**ADDENDUM NO. 5
TO THE
CONTRACT DOCUMENTS**

**HILLCREST AND DONLON
BOOSTER PUMPING STATION IMPROVEMENTS
ANTIOCH, CALIFORNIA
P.W. 477- BP2**

**ISSUED
October 8, 2020**

RVSS (Soft Starter)

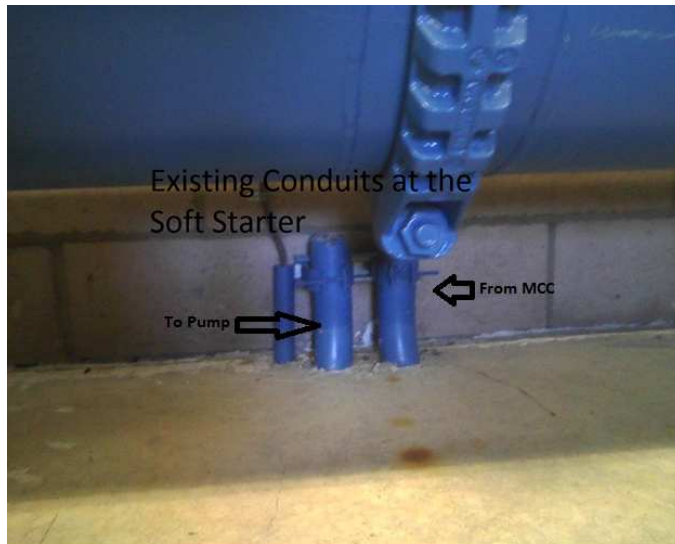
The preferred Soft Starter shall be a Solcon RVS-DX. An alternative to this unit is an Eaton S801/S811. The Soft Starter needs to be housed in a NEMA 12 enclosure and the enclosure will be mounted at the location shown below.
